**New Police Station**  
**Inuvik, NT**  
**Project Number: R.050563**  
**Addendum #1**  
**May 21, 2014**

Project Title:  
**NEW POLICE BUILDING  
INUVIK, NWT**

D SECTION  
S7.0

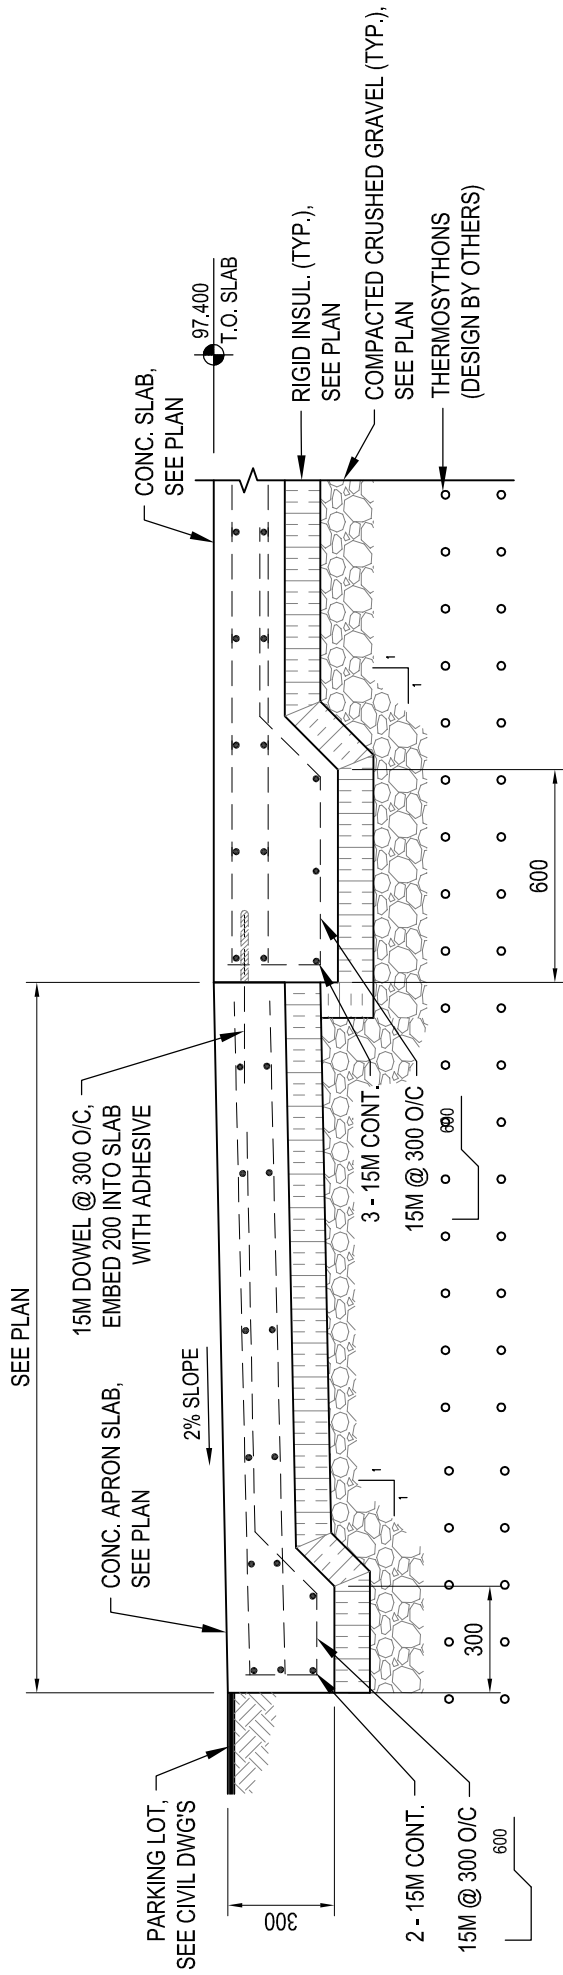
- .1 As shown in Section D/S7.0 (and Detail 1/S7.0), the hinged steel checker plate and embedded bent plate with nelson studs is not required at the interface between the garage apron slab and the parking lot. Refer to attached sketch SSK-13 for the revised section.

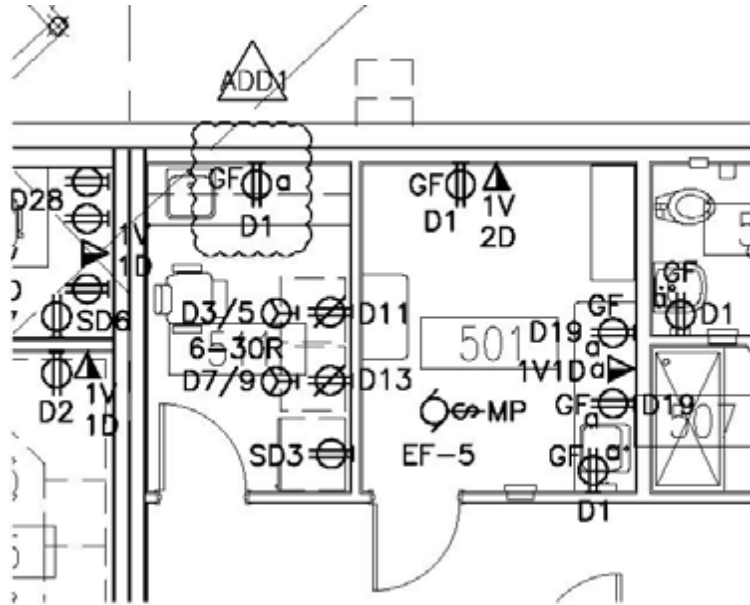
1. Drawing E1.05:

Revise the above-counter receptacle in room 511 at gridlines C-8 to a GF receptacle as shown on the following partial print:
